PRODUCT / PROCESS CHANGE NOTIFICATION

1.1 Company		STMicroelectronics International N.V
1.2 PCN No.		MDG/20/12190
1.3 Title of PCN		ASE Kaohsiung (Taiwan) additional source for TFBGA14x14 for STM32H75 2MB products
1.4 Product Category		TFBGA14x14 for STM32H75 2MB products
1.5 Issue date		2020-09-11

**ASE Kaohsiung (Taiwan) additional source
For TFBGA14x14 240b for STM32H75 2MB products**

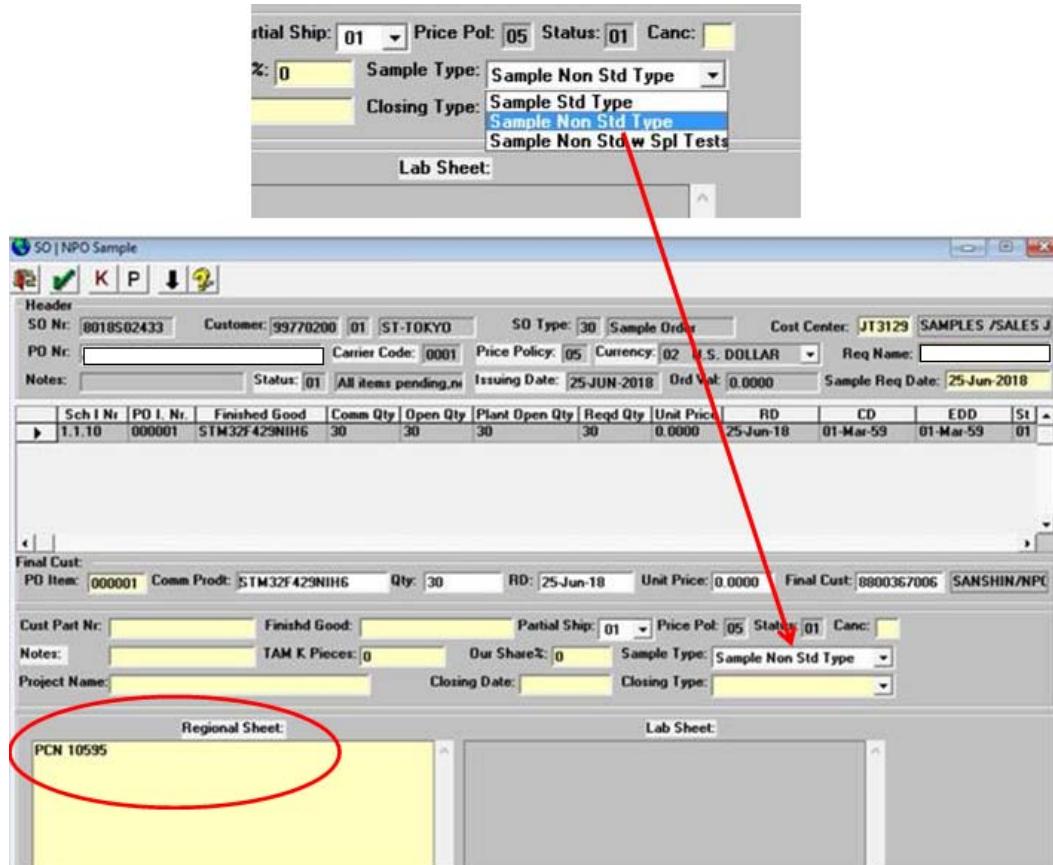
How can the change be seen?

The standard marking is:

.....
.....
 **PP**LLL WX
COO TF YWW

PP code indicates assembly traceability plant code.

The marking is changing as follows:

Existing		Additional	
PP code	Fab	PP code	Fab
7B	Amkor ATP Philippines	AA	ASE Kaohsiung Taiwan
